工程指示 / 要求簡箋(E.I.)

工程指示編號：EI / 6389 / 23

工程名稱：將軍澳日出康城 11

工程項目：幕牆 室內收口鋁料 廁所位 (T2 T3, 3 層 12/F, 15/F, 16/F) 地盤用

美特鋁質有限公司 MIDI Aluminium Fabricator Ltd.				工程號 J858 地盤 康城11期	類別 制圖 J.L.	物料號 - 2023-16-17	圖號 X86459-01
修改 A 日期 16/08	採用工廠 材料顏色 ECD3X1009 9S-XF1	地盤 ✓	图纸名称 幕墙砖墙收口 材料 X86459	復核 - 批准 -	數量 - 單件重量 - (KG)

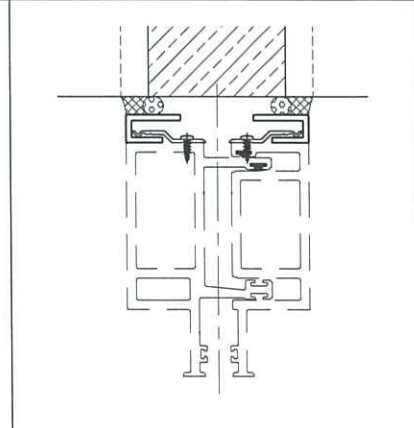
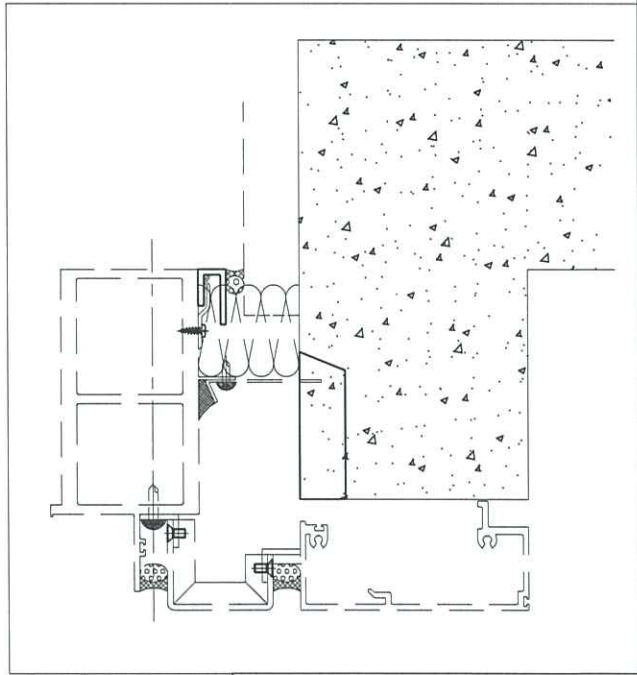
C 版：因廁所位的收口鋁料位置圖有誤，A 座 B 單位的廁所位是用 X86459-01A 請生產 T2, T3 12/F, 15/F, 16/F X86459-01A 的用量 (12 支, 2370mm 長) 供地盤使用。

先急出12件
 直開料 72 12.5.16 A
 73 17.

→ 石磚牆間牆
 → 浴室位 (A座B單位)

编号	L	合计数量
X86459-01A	2370	3164
